Bulletin Number 6

Project No. GESA 2021-1 – Request for Quotes for a Guaranteed Energy Savings
Project at:
Department of Corrections, SCI Frackville, Frackville, Pennsylvania

REQUEST FOR INFORMATION

SCI Frackville Building Square Footage

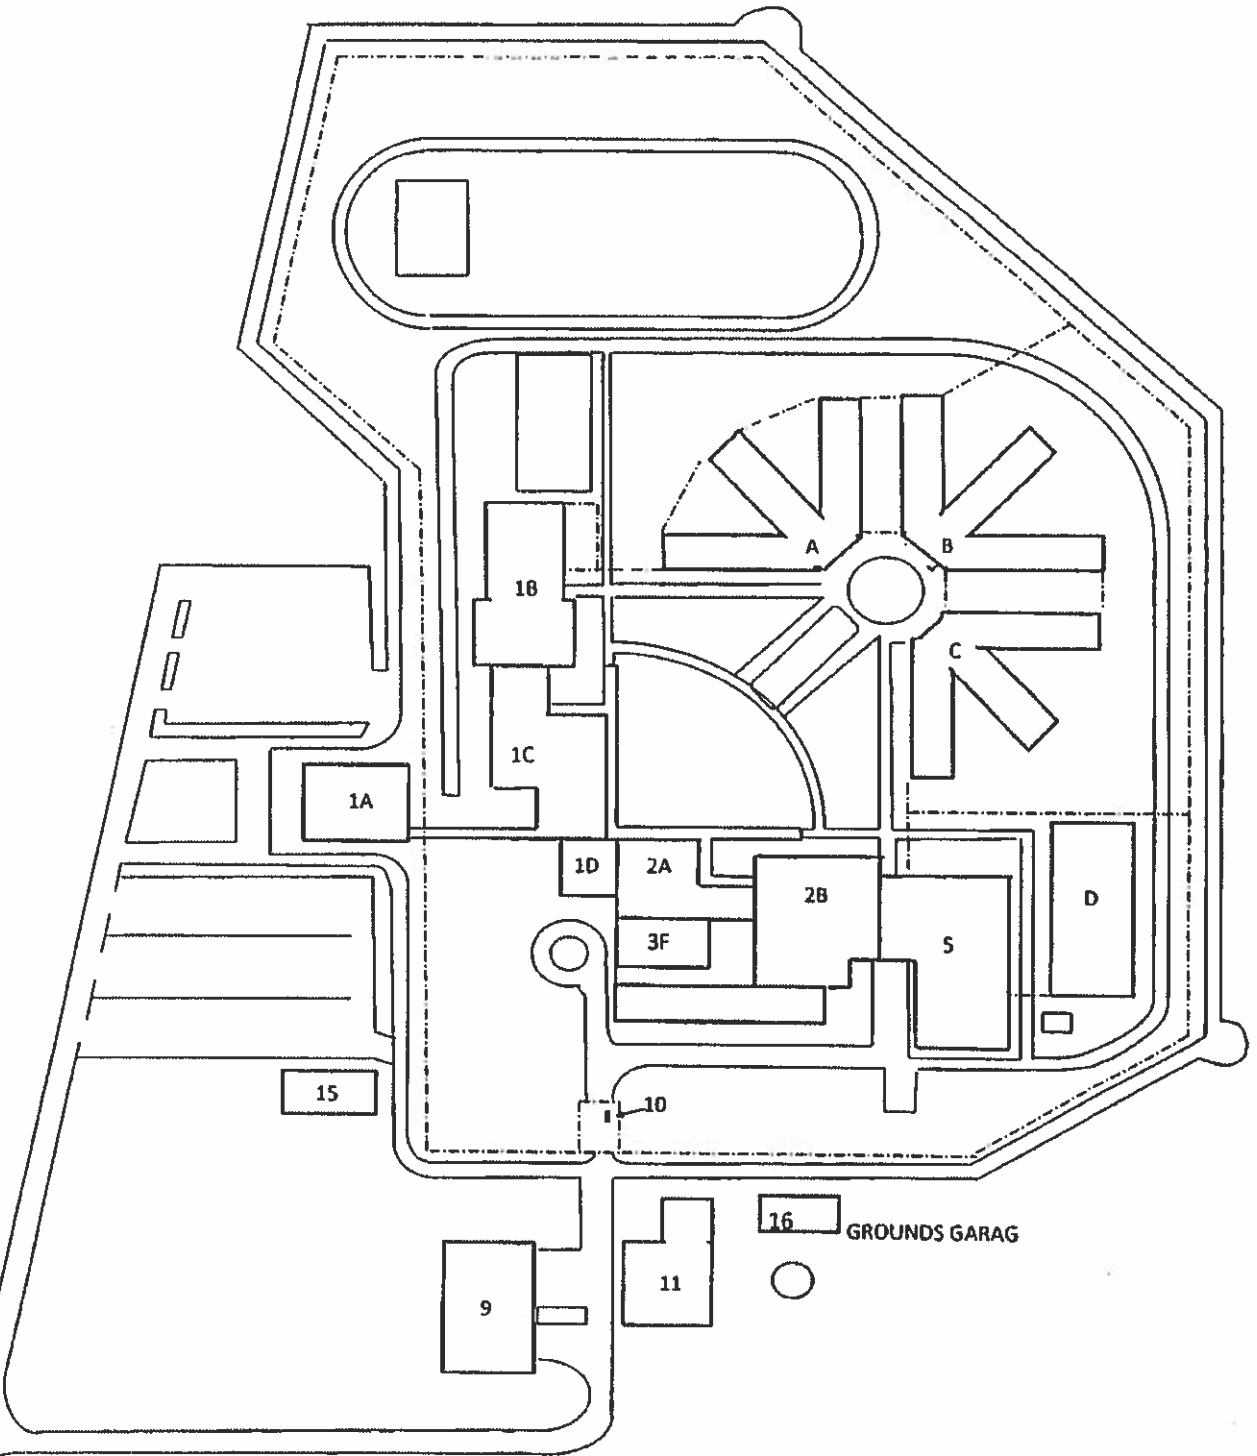
5. Can you provide a list of square footage by drawing, building, and/or room? **A list of square footages is attached to this bulletin as Attachment 1.**
